Lakes & Waterways Advisory Board Regular Meeting August 11, 2020

Approval Shoreline Permit Applications

Shoreline Alteration Permit Staff Report (Seawall & Revetment)

Shoreline Alteration Permit Staff Report (Boathouse & Dock)

MCCRANEY SEAWALL SITE PLAN
1216 NORTH PARK AVENUE
WINTER PARK, FL 32789

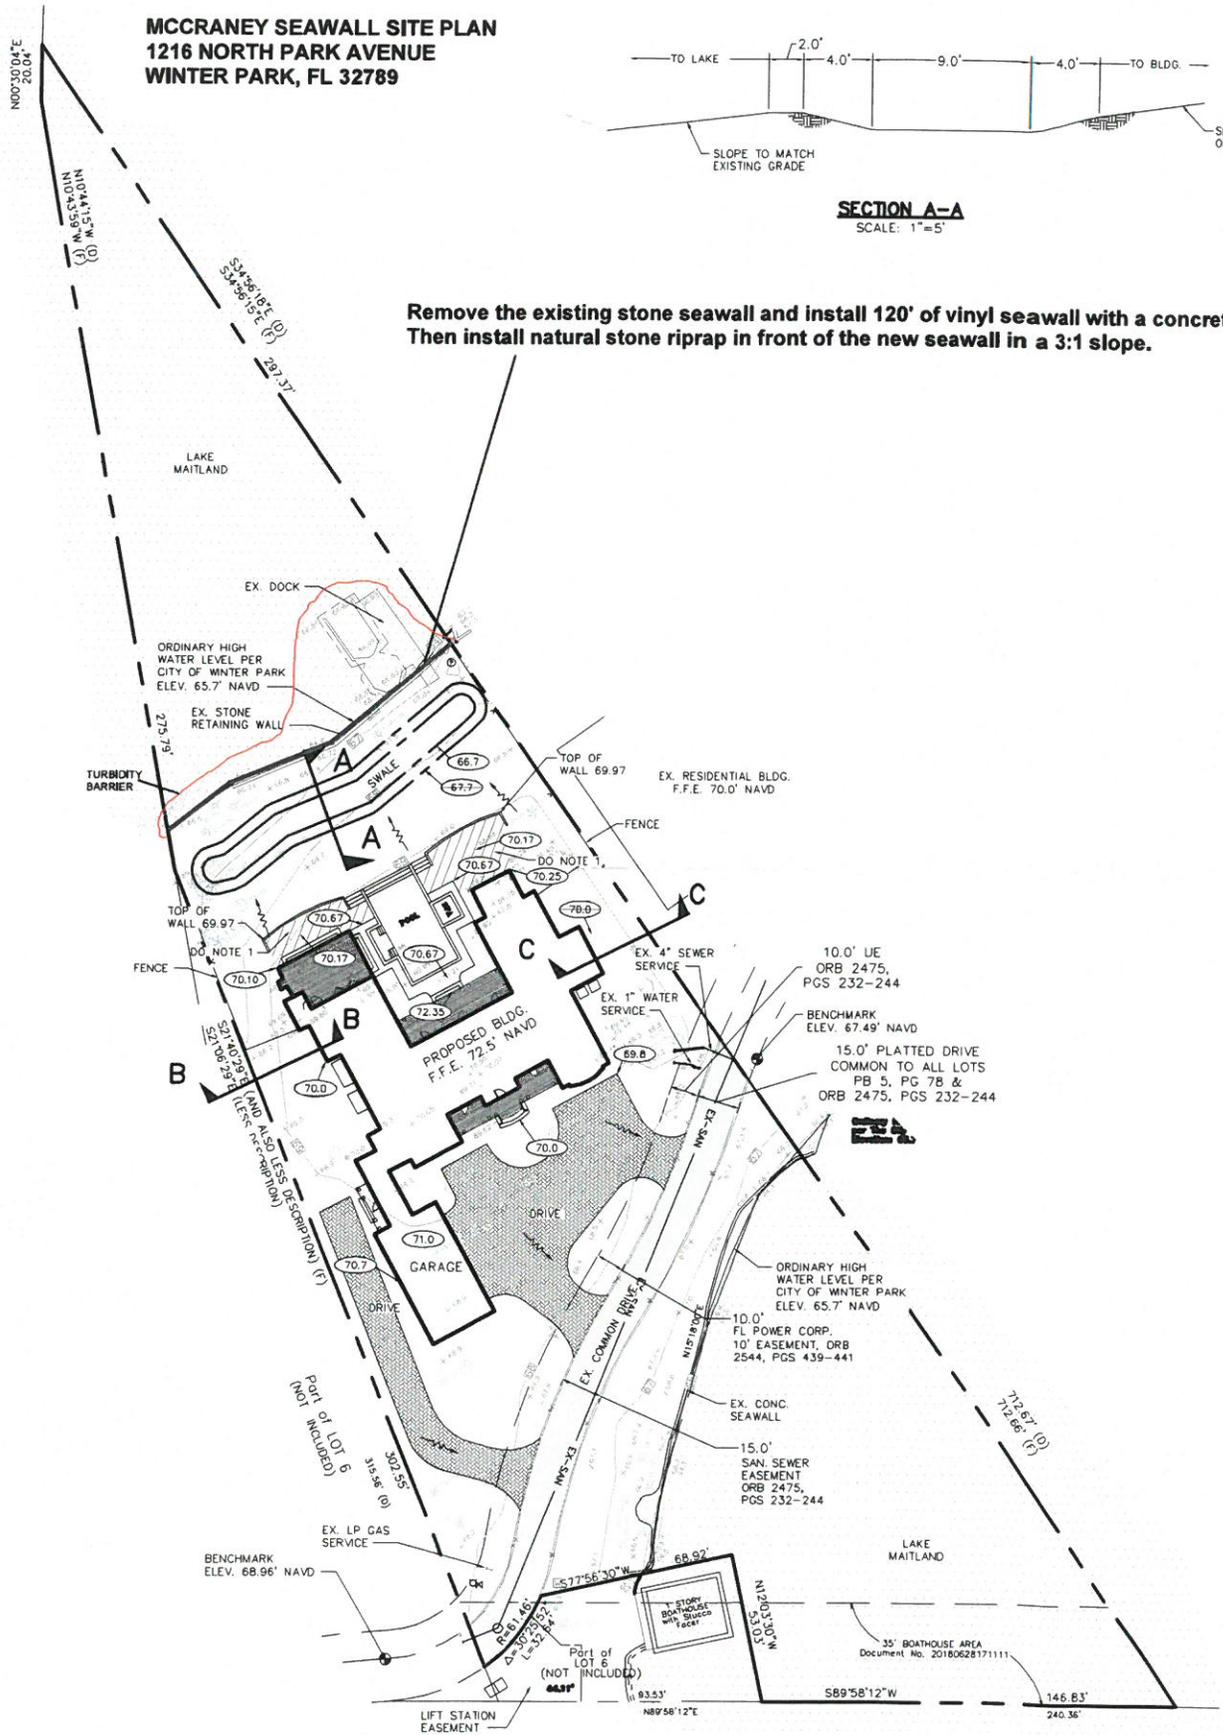
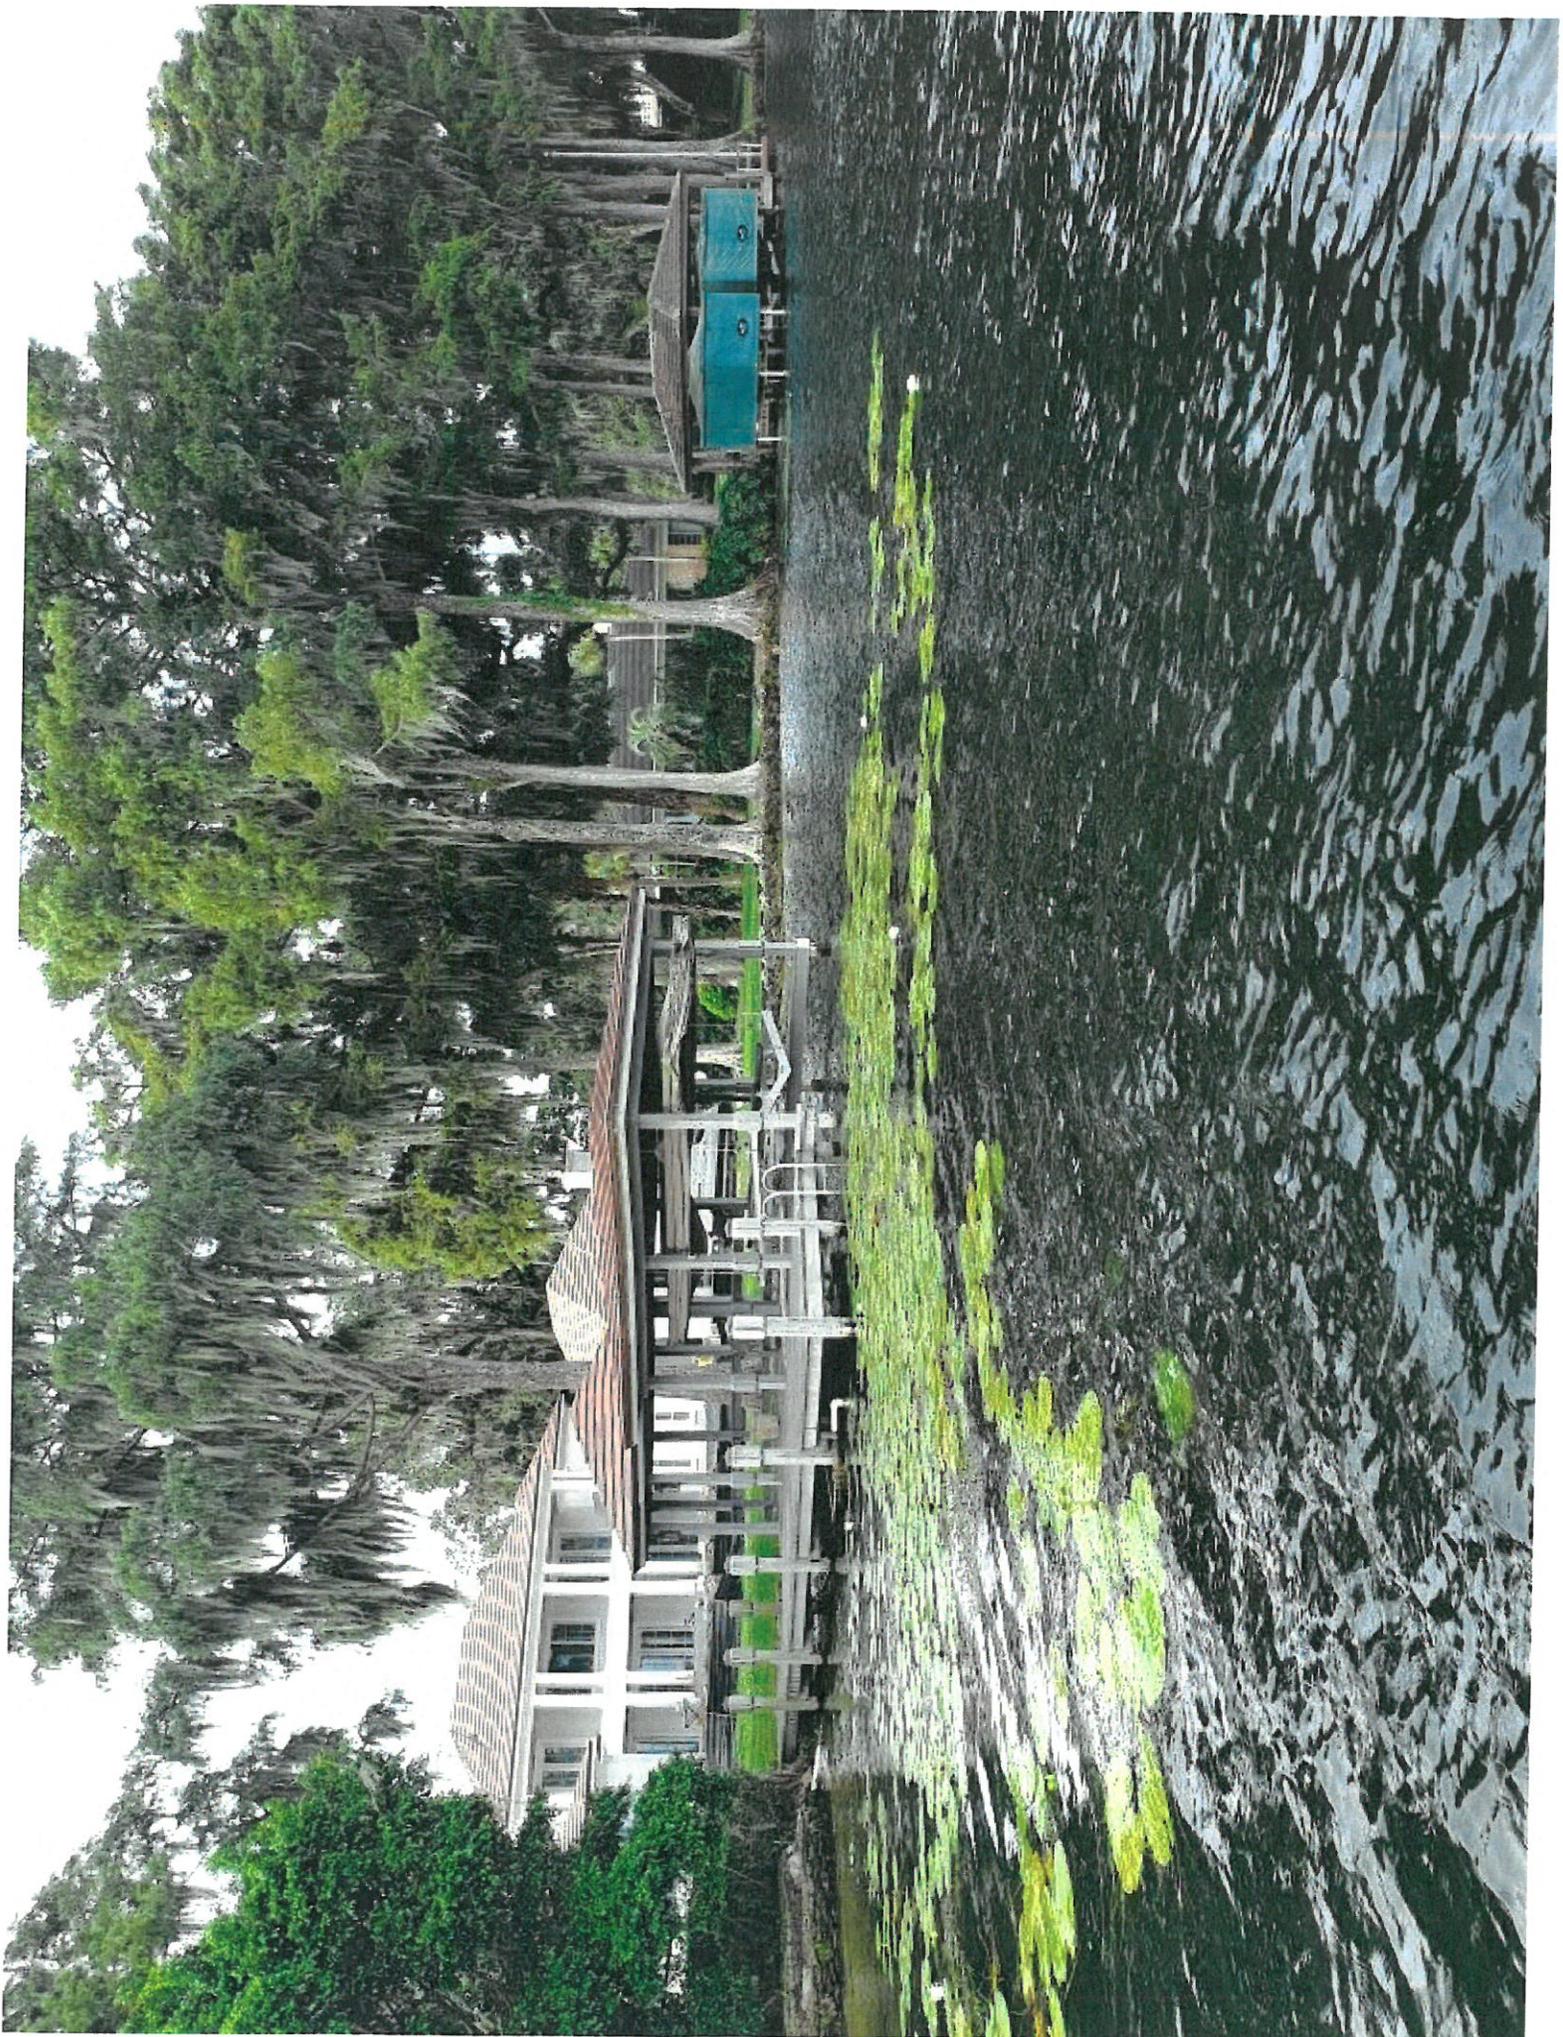
Seawall Parameter	Proposed	Allowed
Length (feet)	120'	n.a.
Slope (Horizontal:Vertical)	3:1	3:1 min.
Material	Vinyl Seawall with Natural stone riprap	n.a.
Existing Erosion Problem (Yes/No)	Yes	Must have existing erosion problem
Meets vegetation requirement	No See recommendations	n.a.

This project is located at on Lake Maitland. The applicant would like to replace the existing stone seawall with a vinyl seawall and install riprap in front at a shoreline length of 120' and at a 3:1 slope. Planting is required to be brought up to code.

- Planting the shoreline to current standards must be completed prior to completion of construction activities. (120 feet of frontage less 50 foot access corridor leaves 70 feet of shoreline that must meet the planting criteria. Existing lily pads can count for 30%, or 21' feet of the requirement leaving 49' feet that must be planted with 4 rows of native, emergent, aquatic plants on 2 foot centers ($49/2 \times 4 = 98$ plants). See attached list of recommended plants.

ZONVOS ELEVATION
1119 PRESERVE POINT DRIVE
WINTER PARK, FL 32789

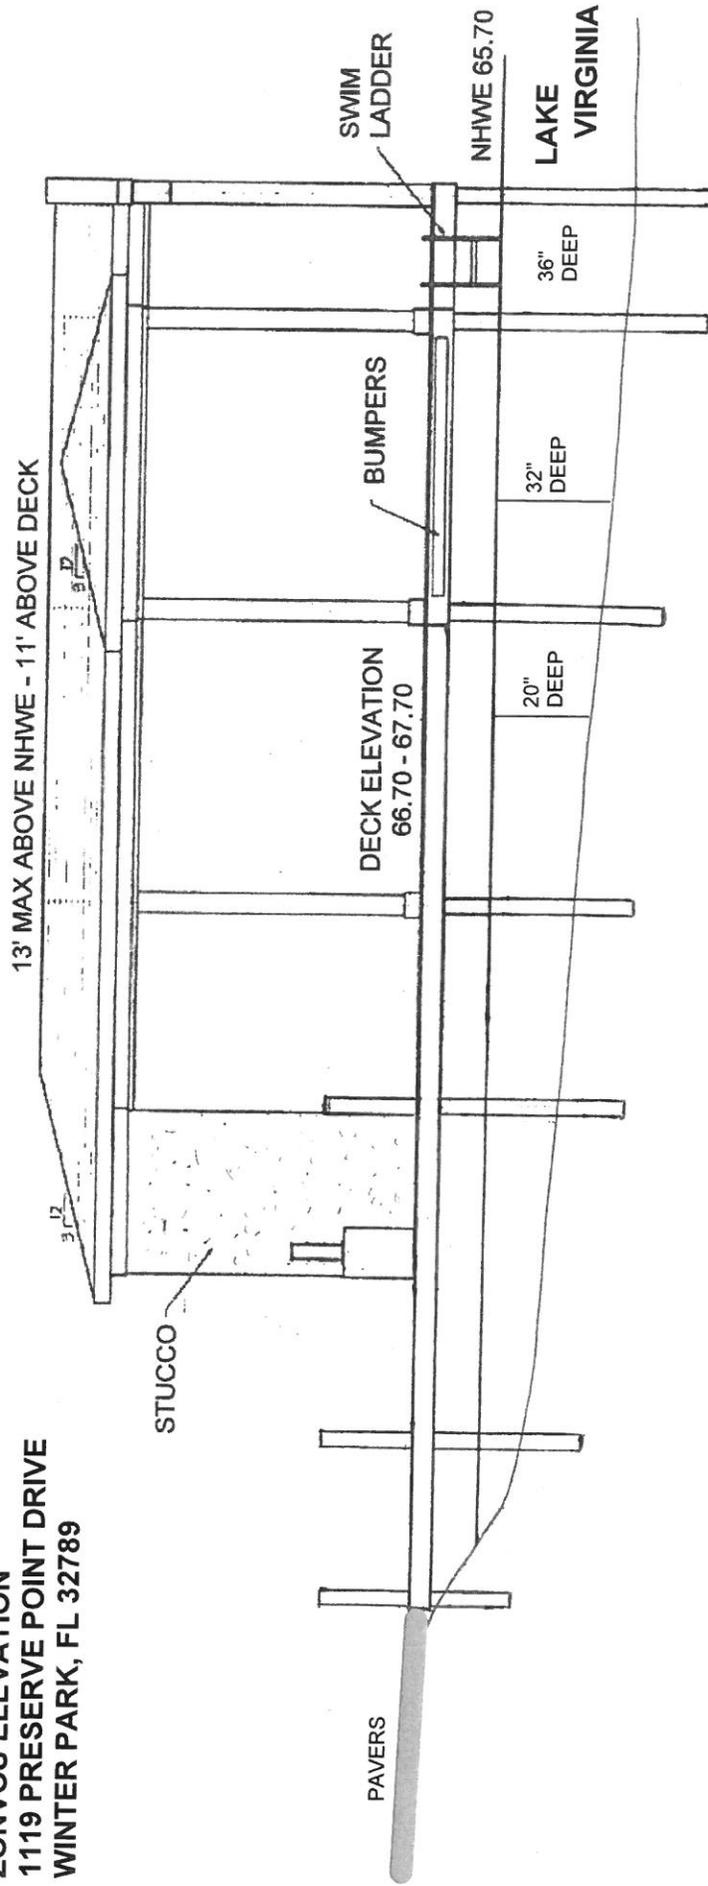
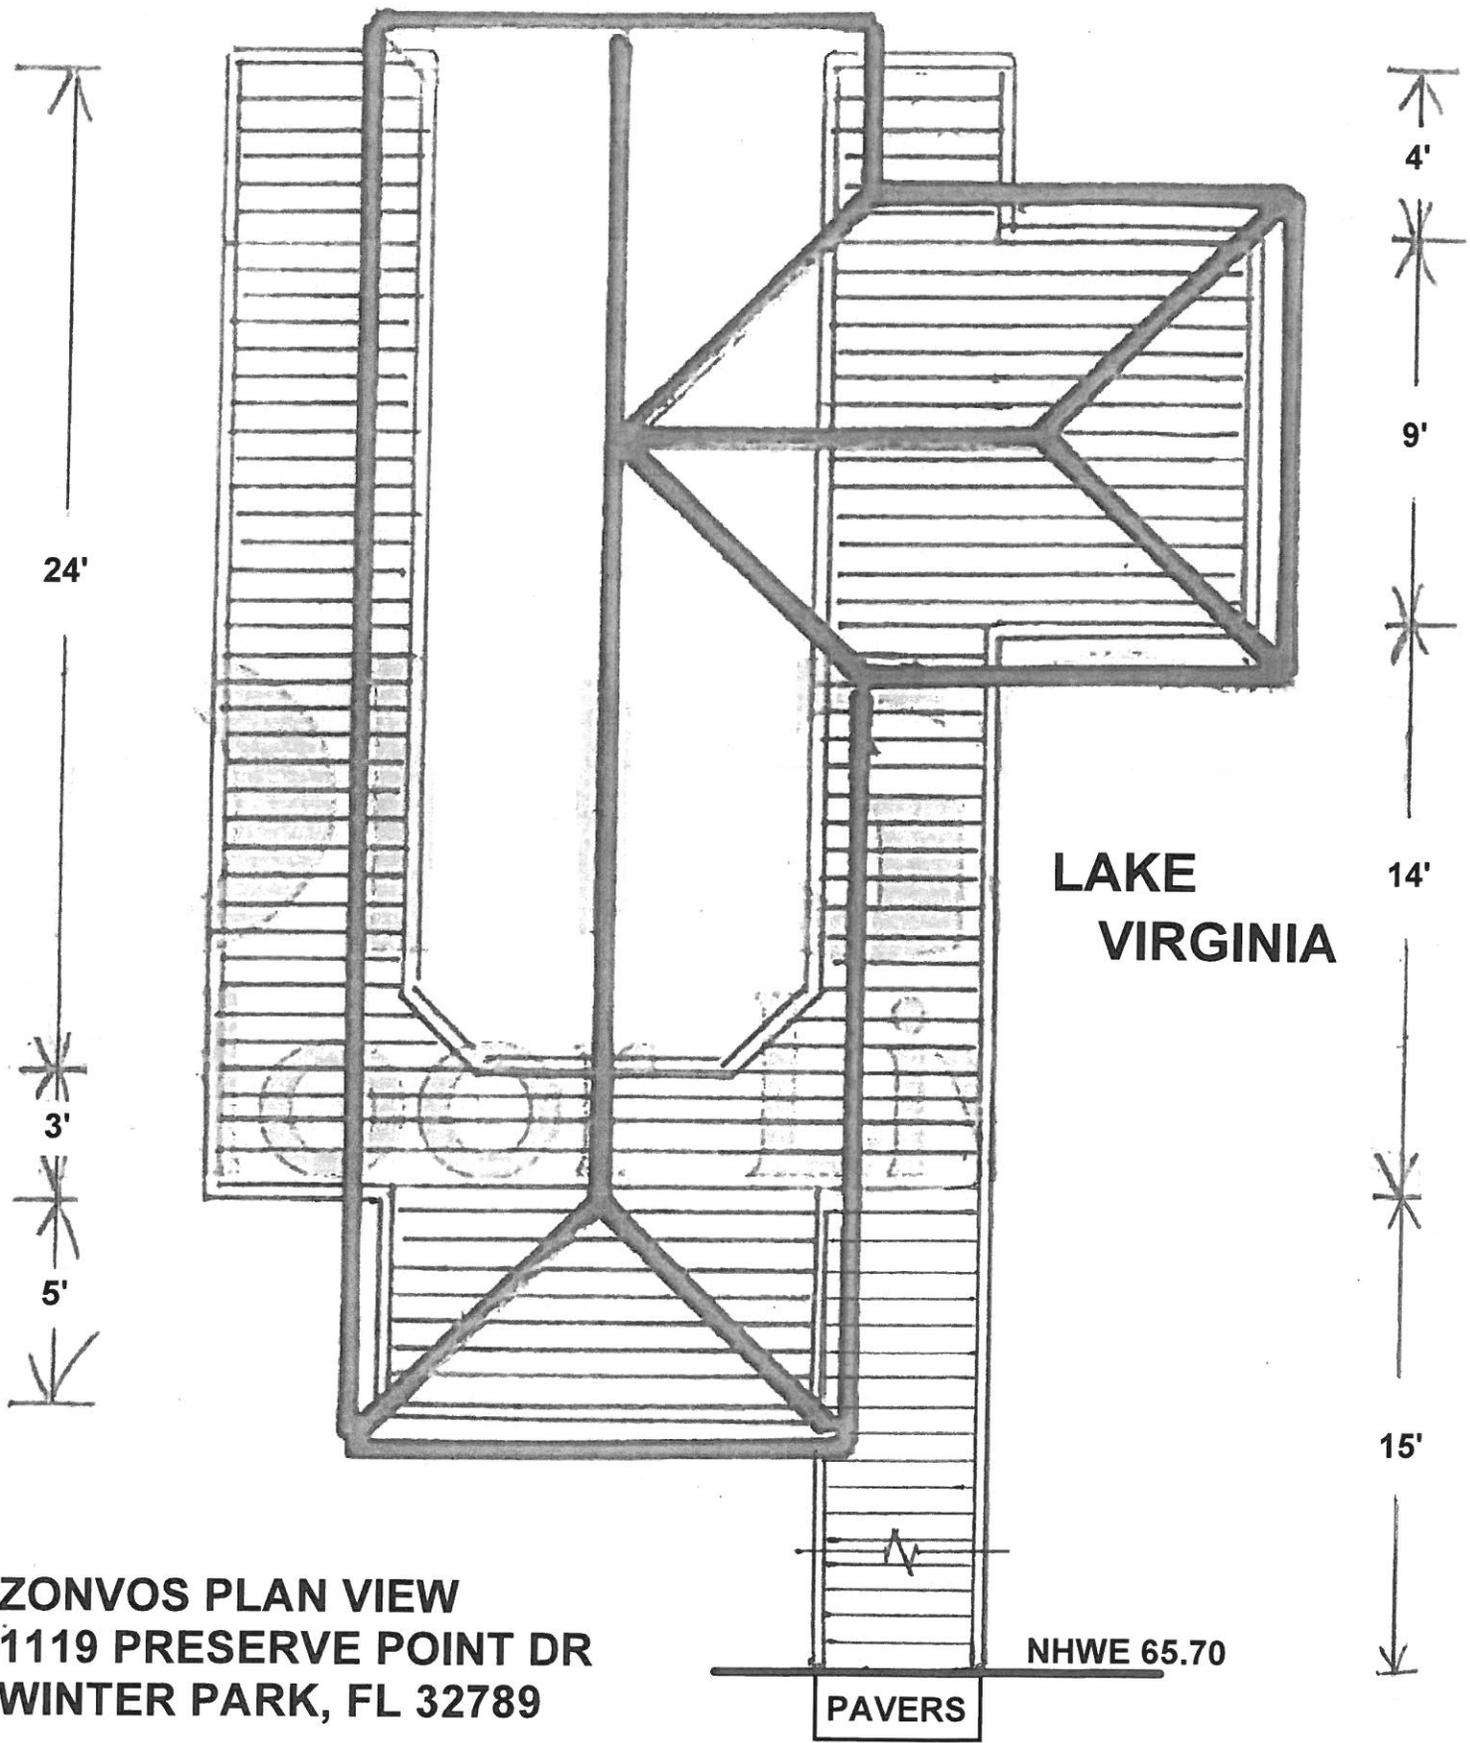
Dock Parameter	Proposed	Allowed	Variance Required?
Total Area (ft ²)	650	600 max	Yes
Length from OHW (ft)	42	30	Yes
Height of Roof (ft above deck)	11	11 max.	No
Height of Deck (ft above OHW)	1-2	2 max.	No
Enclosures?	50 SF	80 ft ² max (no plumbing/water allowed)	No
Side Yard Setback(s) (ft)	>50	10 min*	No
Meets Vegetation Criteria?	Yes	None May be Cleared.	n/a

There are cypress trees and vegetation present, but a boardwalk style dock leading to the lake should not impact the existing buffer or cypress trees/knees. The lake is shallow and additional distance from the shoreline is necessary to allow for adequate depth. Approval.
